UNITED STATES PATENT AND TRADEMARK OFFICE

10/562,223

Office Action Summary	Application No. 10/562,223	Applicant(s) BERENS, ULRICH	
	Examiner GEORGE D. BOZADJIAN	Art Unit 1792

DETAILED ACTION

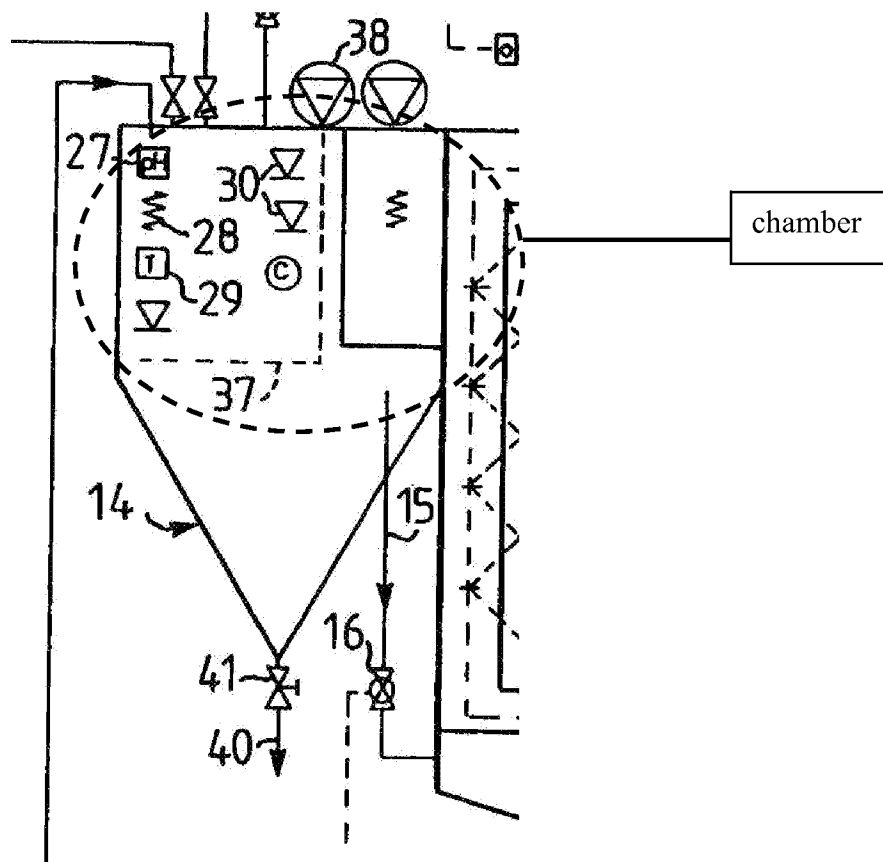
'314 teaches a device (Fig. 1) for purification of machine parts contaminated by oil and grease [Title; Abstract; Figs. 1-2; page 5, lines 21-24], comprising:

a purification housing (1) which can be locked with a lid (2 is a lid that opens and closes so as to seal the washing chamber. For a lid to stay closed and seal a machine that has movable parts, the lid has to be obviously locked), in which a support member (1 and 3 provide a system to hold objects) for receiving the a fluid provided in the housing acts upon the parts to be purified

which are provided on the support (the nozzle system sprays liquid in 1 upon the parts) and a bioreactor (14) for treating the purifying fluid (14 treats the composition of the purifying liquid), where the purifying fluid is provided in a closed circuit via a discharge line (10, 17 and 18) and a supply line (15) between the purification housing and the bioreactor [Abstract; page 5, line 21 – page 6, line 24; page 7, lines 1-25],

a valve (18 is located between the blowing system and the purification housing), which valve is opened for the purifying fluid only at the temperature level of the bioreactor [Fig. 1; page 9, lines 1-8].

It does not teach the support member being a basket, a heat exchanger and its location on the discharge line and the valve being located between heat exchanger and the bioreactor. However, '180 teaches a washing machine for washing items having support member in the form of a basket (16) to support items during washing [Title; Abstract; Figs. 1-2; col. 2, lines 7-14]. Therefore, one of ordinary skill in the art at the time the invention was made would have substituted the support member of '314 with the basket of '180 to held items to be washed. '180 does not teach a heat exchanger. However, '371 teaches a wastewater treatment apparatus that uses bacteria to treat contaminants in the wastewater, the apparatus having a conduit discharge and feed system wherein a heat exchanger (83) is located in the discharge line (81-88) which is capable of heating or cooling the fluid passing through the conduits [Title; Abstract; Fig. 1; col. 4, lines 4-11; col. 2, lines 15-29]. Therefore, one of ordinary skill in the art at the time the invention was made would have placed the heat exchanger of '371 in the discharge line of '314 to have treated the condition of the purifying liquid that carries the bacteria from the washing apparatus to the bio reactor. As for the matter of rearranging the valve and heat exchanger along

the discharge line, it would have been obvious to one having ordinary skill in the art at the time the invention was made to have rearranged the valve (18 in '314) and the heat exchanger to have been placed in the matter the limitation is claimed, since it has been held that rearranging parts of an invention involves only routine skill in the art – *In re Japikse*, 86 USPQ 70. This rearrangement would allow the valve to open/close access for the fluid to the bioreactor based on an operator's choice. Additionally, having the valve located after the heat exchanger would give an operator the choice of how long to keep the fluid in the heat exchanger to be cooled or heated before creating a flow path by opening the valve.

7. Claim 2: '314 teaches all the limitations of claim 1 above. It further teaches a pump (11) which circulates the purifying fluid is provided between the valve (18) and the housing (1) [Fig. 1; page 6, lines 5-13]. It does not teach the pump located between the heat exchanger and the valve. It would have been obvious to one having ordinary skill in the art at the time the invention was made to have placed the pump (11) between the heat exchanger and the valve, since it has been that rearranging parts of an invention involves only routine skill in the art – *In re Japikse*, 86 USPQ 70. This rearrangement would allow the pump to provide flow pressure for the fluid to the bioreactor based on an operator's choice. Additionally, having the pump located after the heat exchanger would give an operator the choice of how long to keep the fluid in the heat exchanger to be cooled or heated before creating a flow pressure by activating the pump.

9. Claim 6: '314 teaches in an upper area of the bioreactor a chamber (see figure below) is located in order to receive the treated purifying liquid [Fig 1 shows supply line 15 directed from the top, i.e. upper chamber, of the bioreactor to device 1].

10. Claim 7: '314 teaches all the limitations of claim 7 above. It further teaches the chamber is connected to the supply line 15 which is connected to the spray nozzle system (the supply line is connected to the nozzle via 9, 10, 12, 6, and 5, which ejects the liquid through nozzle 8) [Abstract; page 5, line 21 – page 6, line 24; page 7, lines 1-25].
